## Improved 05T Open Drive And 06T Semi-Hermetic Screw Compressors

This month, Carlyle Compressor Company will phase in redesigned screw compressor housings. The new housings are a more compact, cleaner design. The new design mounting footprints are the same as the original compressors. Some of the compressor connection points had to be relocated. Each relocation is minor and should be transparent to most customers. Details on these changes are as follows.

Figure A

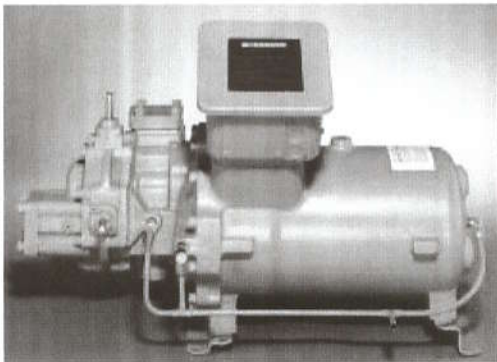
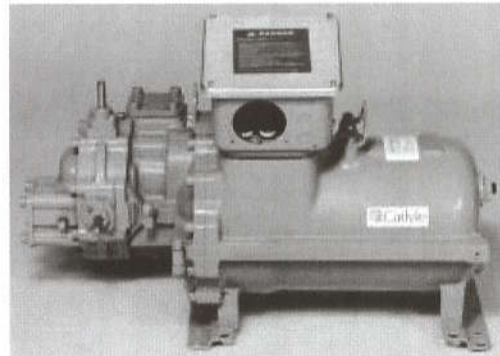
- The external oil manifold tubing was eliminated (Figure A) and replaced

with a machined passageway within the compressor casting (Figure B). The change eliminated the inlet tee mounted on over two feet of exposed fabricated tubing, a fitting on the motor barrel, and the tee fitting at the rotors. The rotor fitting

is now an elbow fitting. These changes have reduced the overall width of the compressor.

- Every new style compressor will have a warning tag on the oil fitting to alert the installer of where to connect the oil system.  
NOTE: Oil connection is the bottom of the tee fitting. See drawing Page 8.

Figure C

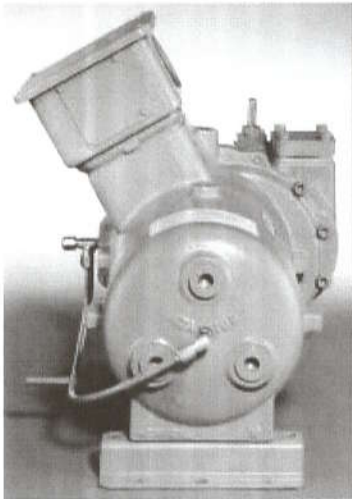
- The terminal box on the compressor is in the same general location. The new casting is narrower and shorter, allowing the terminal box to be mounted at a lower angle on the casting. This change reduces the overall height and width of the compressor. See Figures A and C for the original terminal box and Figures B and D for the new terminal box.

- In order for Carlyle to optimize our casting production, the economizer port on the 06T compressors was relocated. The original position was at twelve o'clock (Figure C) on the motor end of the casting. The new location is between the ten and eleven o'clock position (Figure D).

Figure E

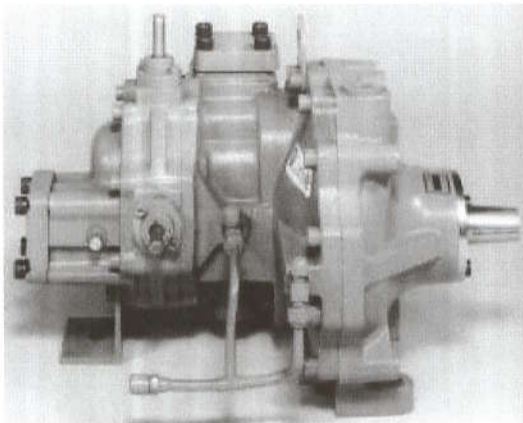
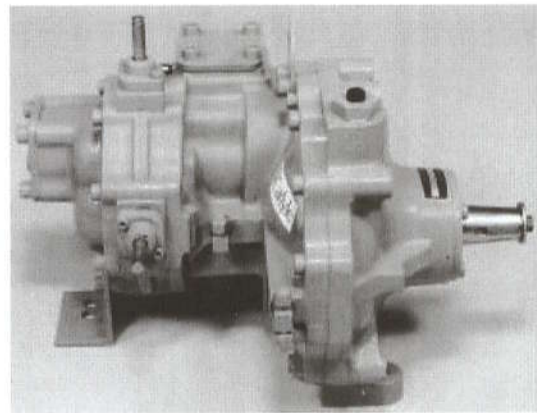
- The external oil manifold tubing (Figure E) has been eliminated and replaced with a machined passageway (Figure F) within the compressor casting. The change eliminated the inlet fitting mounted on an exposed fabricated tubing. Also, the tee fitting at the rotors is now an elbow fitting.

NOTE: Oil connection is the bottom of tee fitting. See drawing Page 10.

**FIGURE G**  
NEW  
INTERNALLY MANIFOLDED  
8ST SEMI-HERMETIC DESIGN  
(MANUFACTURED STARTING MARCH 1997)

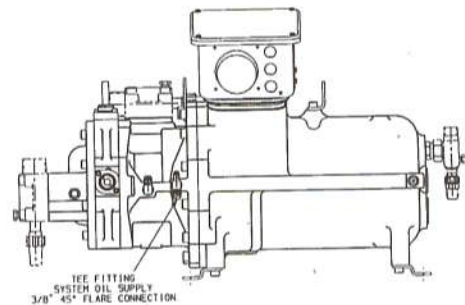
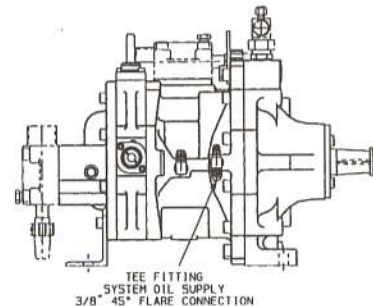
1. The service technician will have to field fabricate a short piece of copper tubing to connect the existing oil system feed line and the compressor tee fitting on the new style body. See Figures G and H below and Pages 8 and 10 for details.

**FIGURE I**  
NEW  
INTERNALLY MANIFOLDED  
95T SEMI-HERMETIC DESIGN  
(SHOWING 0TA0967D RETROFIT OIL ADAPTER)

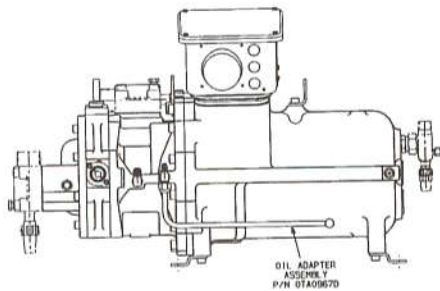
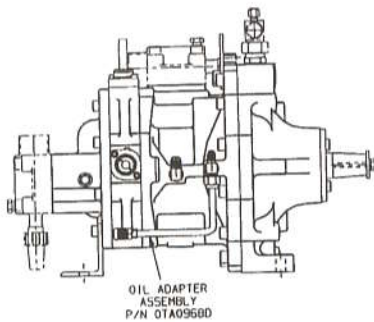
2. The technician can install the Carlyle designed oil adapter assembly available through the Carlyle OEM Sales Department. The adapter for semi-hermetic compressors is Figure I, P/N 0TA0967D. The adapter for open drive compressors is Figure J, P/N 0TA0968D. The adapters have threaded fittings at both ends.

**FIGURE K**  
NEW  
INTERNALLY MANIFOLDED  
95T SEMI-HERMETIC DESIGN  
(SHOWING FIELD-MODIFIED EXTERNAL OIL MANIFOLD)

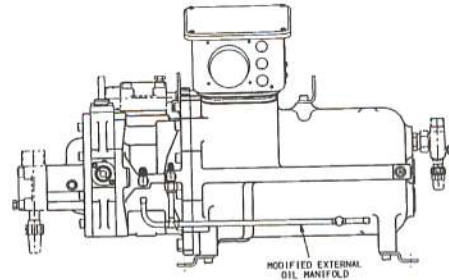
3. Modify the original external oil manifold as follows:
  - For semi-hermetic compressors – cut and cap the two side branches of the manifold as noted in Figure K.

The caps must be brazed and capable of holding at least 405 psig pressure. The cutting and brazing must be done with care, as any piece of the copper tubing or of solder material left in the system can cause serious damage to the replacement compressor.
